RE: P.Z. 14-2013 St. Luke's Hospital-West Campus (175 S. Woods Mill Rd.): A request for a zoning map amendment from "MU" Medical Use District, "R-2" Residence District and "FPNU" Flood Plain Non-Urban District to create a new "MU" Medical Use District for a 40.3 acre tract of land located west of the intersection of South Woods Mill Road and Hwy 141 (18Q140343, 18Q510278, 18Q230204 and 18Q210211).

Planning Commission Vote Report

RE: P.Z. 14-2013 ST. LUKE'S HOSPITAL – WEST CAMPUS

PRELIMINARY PLAN FOR "MEDICAL USE" ZONING AMENDMENT PARCEL "B" PARCEL "D"

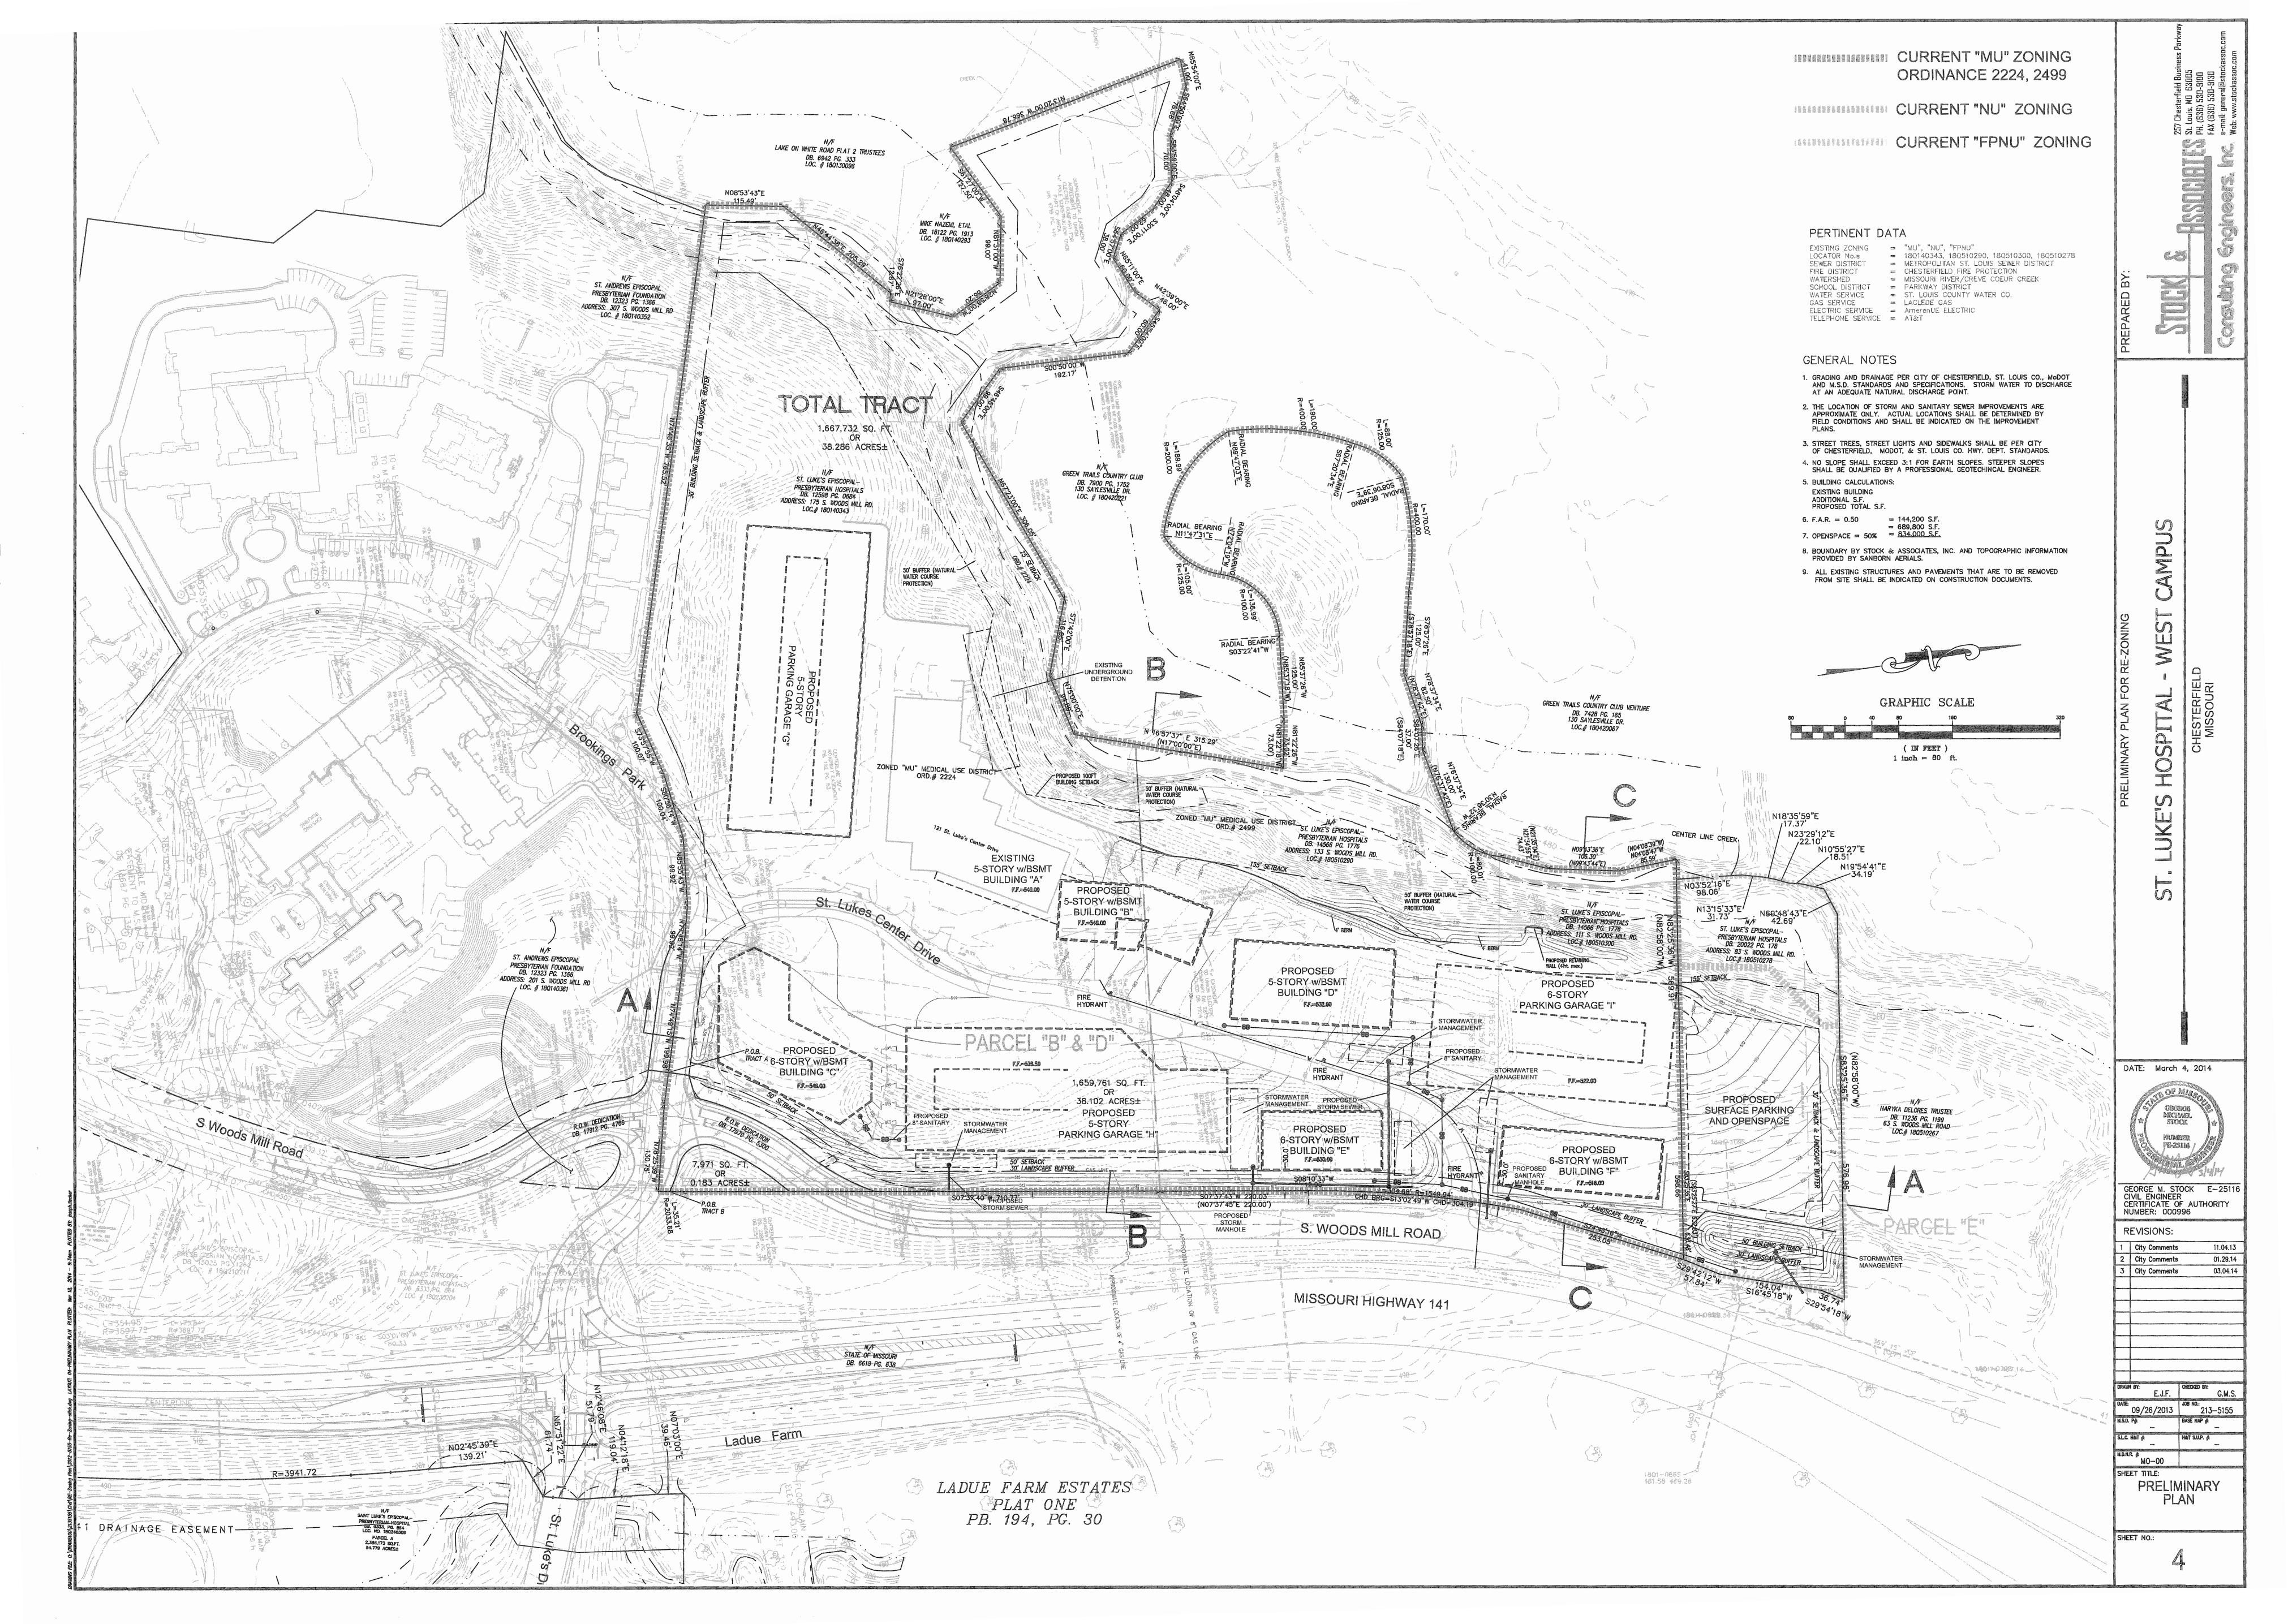
- 2. Correction of setbacks and landscape buffers on the Preliminary Plan as follows:
 - Depict the required 30 foot landscape buffer along the southern border of Parcel B.
 - While the previous ordinance permitted a 25 foot setback along the southern border of Parcel B, evaluate a 30 foot building setback to accommodate the 30 foot landscape buffer.
 - Identify the 30 foot landscape buffer along the east and north boundary of Parcel E.
 - The 25 foot building setback should be increased to accommodate this 30 foot landscape buffer on Parcel E. Amend the north setback to be 30 foot.
 - The east setback for Parcel E is 50 foot.

The Revised Plan shows the correct setbacks and landscape buffers.
